OVERLOOK STATION SUBDIVISION

APPLICATION NUMBER 7 DATE March 15, 2007

DETAIL SITE PLAN

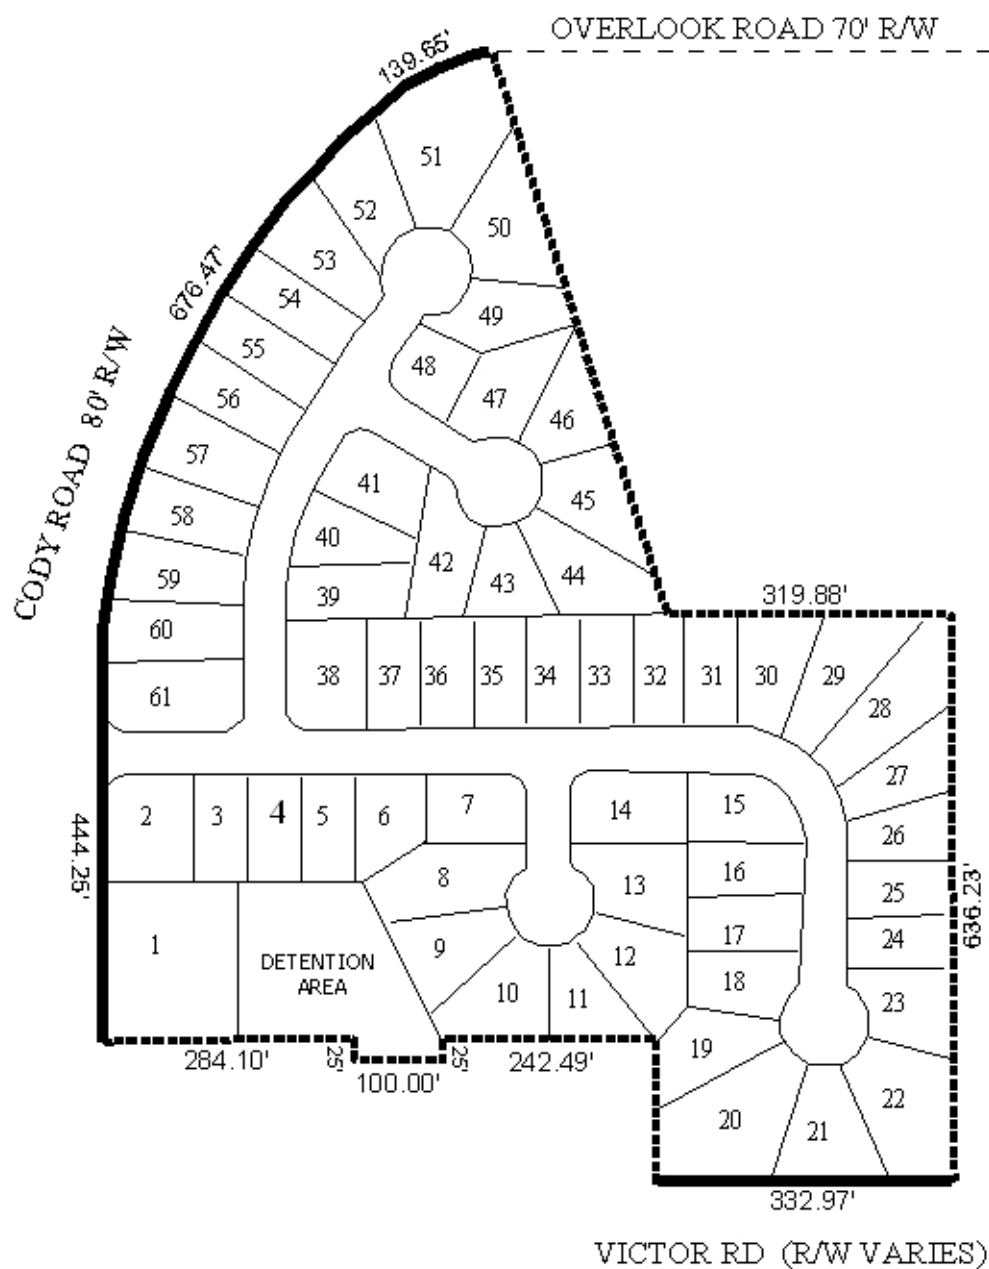
The purpose of the application is to create 61 residential lots from one parcel and a portion of a parcel. The remainder of the second parcel will remain in use by an adjacent church. The application should be revised to include the full extent of the second parcel and, in fact, should include a third parcel so that the church site can be consolidated onto a single lot.

The site fronts Cody Road, Overlook Road and Victor Road. Cody Road is a proposed major street with an 80-foot right-of-way, which is less than the 100-foot right-of-way recommended in the Major Street Plan component of the Comprehensive Plan. Overlook and Victor Roads are minor streets, however, sufficient right-of-way should be dedicated along Victor Road to ensure at least 30 feet, as measured from the centerline due to the lack of curb-and-gutter: the right-of-way for Overlook Road is adequate. Access to Victor Road from individual lots or the overall subdivision should be denied.

The site involves the creation of new streets. Because the site adjoins an approved subdivision to the East, a street-stub should be provided to connect with the approved Overlook Place subdivision.

The minimum building setback line is not depicted on the plat. The plat should be revised to depict the minimum building setback line from all street frontages.

No easement or access is depicted to the proposed detention area. The plat should be revised to show at minimum a drainage easement to the detention area.

Based on the preceding, this application is recommended for Holdover until the April 19th meeting, with revisions due by March 26th, to allow the applicant to undertake the following: 1) revision of the application (to include labels, postage and lot fees) and plat to include the entirety of the parcel and an additional parcel (so that a lot can be created for the church); 2) revision of the plat as needed to reflect necessary right-of-way dedications along Cody Road (50-feet from centerline) and Victor Road (30-feet from centerline); 3) revision of the plat as necessary to provide a street stub to the approved Overlook Place subdivision to the East; 4) revision of the plat to depict the required minimum building setback line from all street frontages; and 5) revision of the plat to show a drainage easement or direct access to the detention area.
